# Urgent Field Safety Notice Product Correction

Product Name	List Number	Serial Number	UDI
Mixer	09D59-01 09D59-02 09D59-03	All	Not applicable

This Product Correction letter is to inform you of an issue with the ARCHITECT c Systems Mixer (LN 09D59-01, 09D59-02, and 09D59-03). There is the potential for the mixer blade, attached to the mixer with a screw and nut, to separate from the mixer. The missing mixer blade will result in inadequate mixing of the reaction mixtures leading to potential incorrect results (failed assay calibration, Quality Control (QC) out of range, and/or incorrect patient results). The impact on the test result may vary depending on the assay being performed and the viscosity of the patient sample.

## Appendix A: Mixer Inspection Procedure

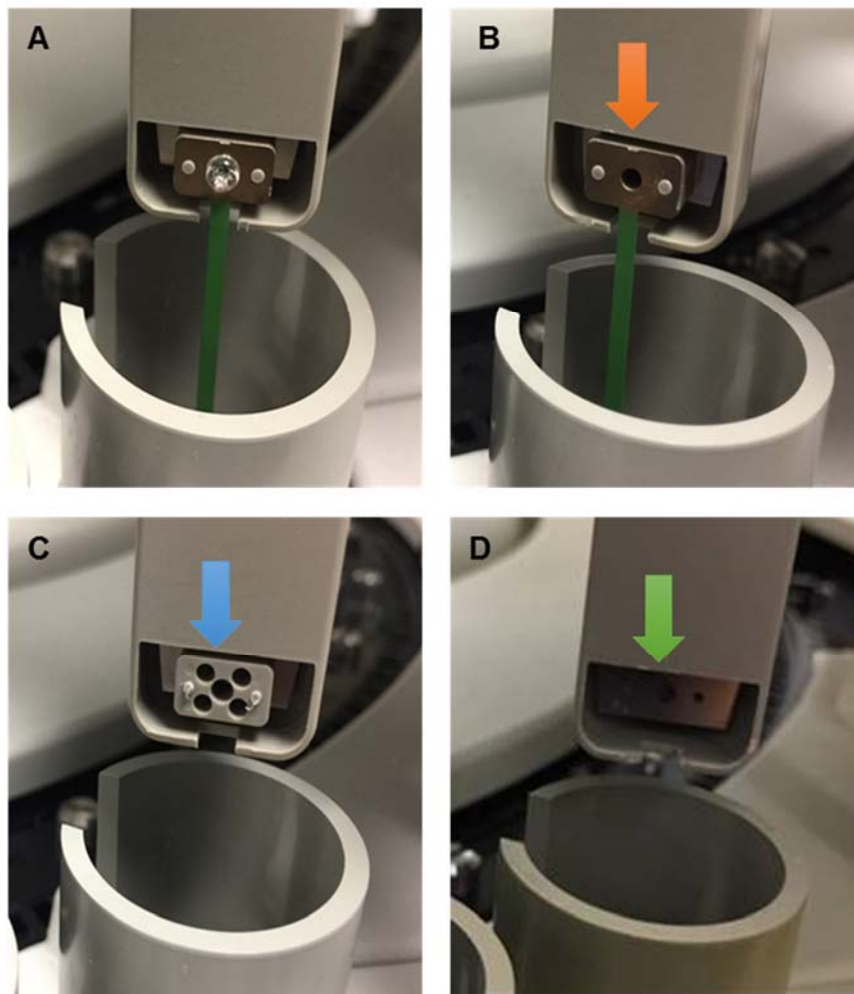
To inspect each mixer, open the rear cover of the processing module and inspect the mixer. Verify the mixer blade and screw is present.

If a mixer blade and/or screw are missing

1. Replace broken mixer. Refer to *Replace the Mixer (c4000, c8000, c16000)*<sup>1</sup>.
2. Replace the cuvette dry tip. Refer to *Replace the cuvette dry tip (c4000, c8000, c16000)*<sup>1</sup>.
3. Follow the instructions in **Appendix C** to inspect all cuvettes to ensure that the screw or nut did not fall into an individual cuvette.

## Appendix D: Additional Precautions for Weekly procedure *6021 Clean Mixers*<sup>1</sup>:

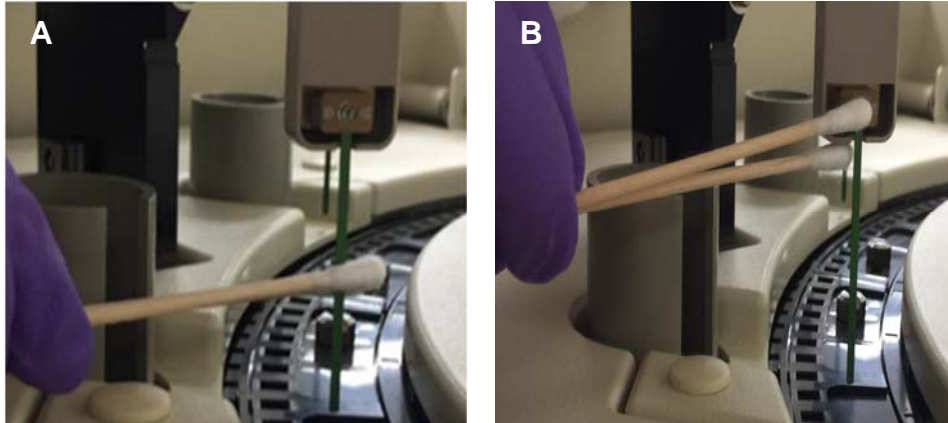
When performing weekly maintenance procedure *6021 Clean Mixers*<sup>1</sup>, it is recommended to not let the mixer screw and 70% isopropyl alcohol come in direct contact.
